Central Planning Authority

Minutes of a meeting of the Central Planning Authority held on **27 March 2024 at 10:00am** in Conference Room 1038, 1st Floor, Government Administration Building, 133 Elgin Avenue

CPA/10/24

Figure 1: Land cover map overlaid on proposed site plan, note the majority of the site is covered by tidally flooded mangrove forest and woodland (Source: DoE, 2023)

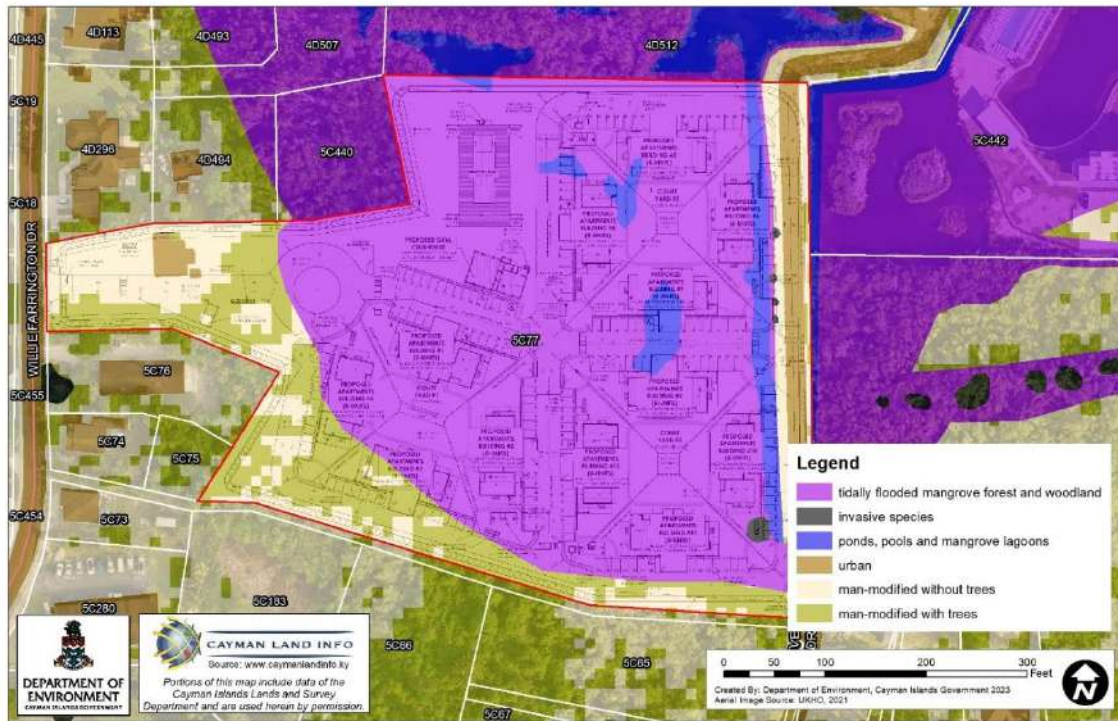
The application site consists primarily of tidally flooded mangrove forest and woodland (refer to Figure 1) and features several ponds or pools.

Figure 2: Site contours overlaid on 2018 aerial imagery (Source: LIS, 2018)

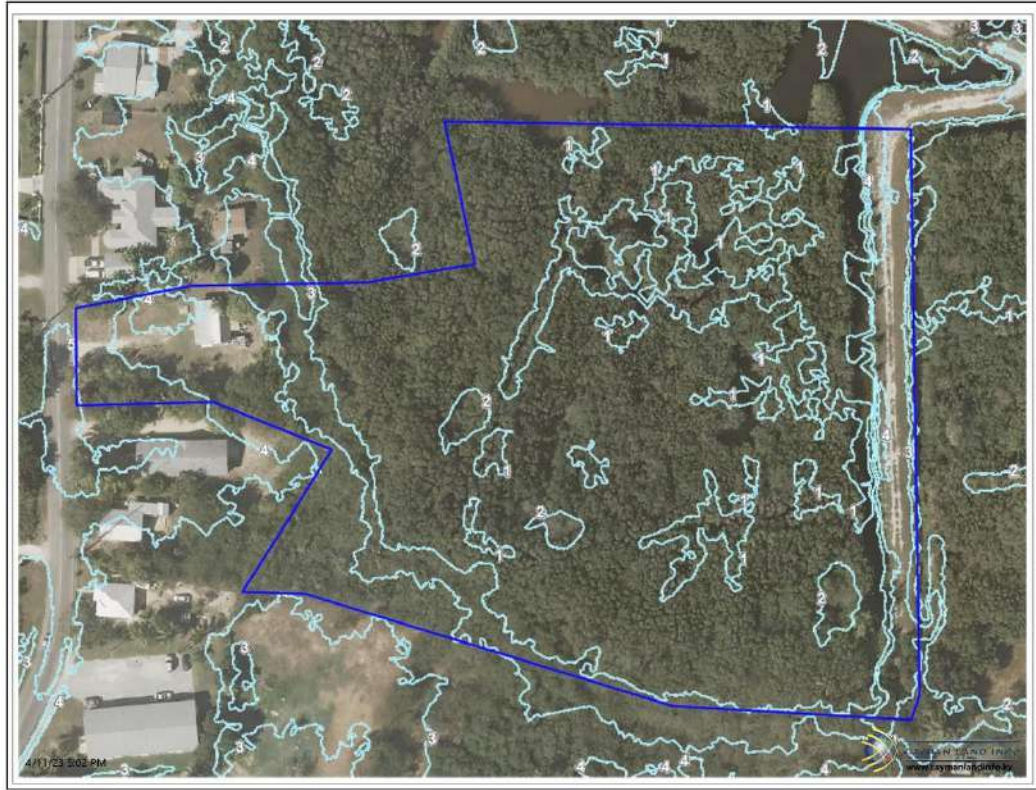
The site is very low lying, averaging around 1 foot above Mean Sea Level (refer to Figure 2). As such, drainage is likely to be a significant concern. We are pleased to see that the revisions to the plan feature a number of areas that have been used to incorporate detention basins or retention ponds and the perimeter of the property features a swale. If incorporated effectively, these measures can be beneficial to the drainage of the site, as well as the surrounding area. We have not been provided with a comprehensive Stormwater Management Plan for detailed review, however we do support the inclusion of these aspects.

We further recommend that the applicant considers the use of porous or permeable paved surfaces in areas of hard standing such as the driveways and parking areas.

Figure 2: A map showing the elevation of the subject parcel with the elevated ridge shown in yellow reaching approximately 24ft above sea level (Source: LIS 2018)

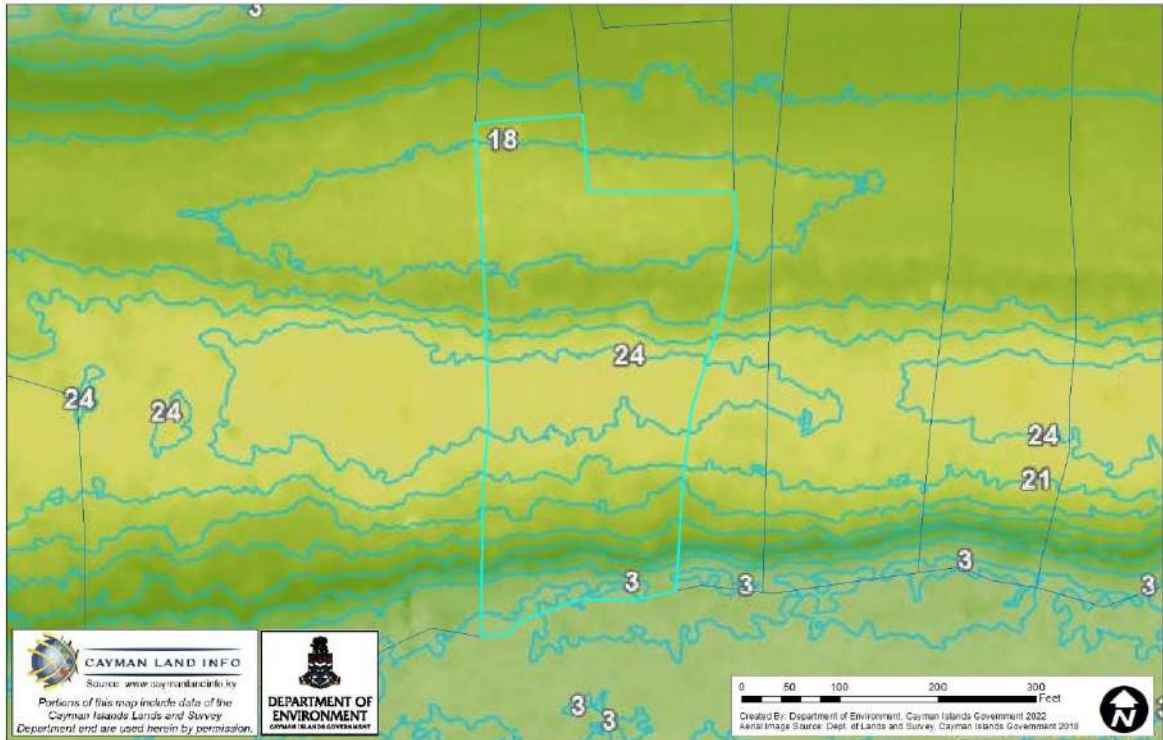
The Department notes that the majority of the subject parcel is primary dry shrubland and dry forest habitat with the northern-most section being previously cleared and man-modified, as shown in Figure 1 below. The subject parcel is also located on an elevated ridge area which reaches heights of approximately 24ft as shown in Figure 2 below. Elevated areas with primary dry forest habitats are known to contain some of the oldest growth native vegetation. These areas are of high ecological value and may contain endemic species.

Should the Central Planning Authority or Planning Department be minded to grant planning permission for the proposed subdivision, the DoE recommends the inclusion of the following conditions in any Planning Approval:

1. *There shall be no land clearing, excavation, filling or further development of the resultant subdivided parcels without planning permission for such works being granted.*
2. *Any future land clearing, excavation, filling or development of the resulting subdivided parcels shall be the subject of a separate consultation with the Central Planning Authority and National Conservation Council.*
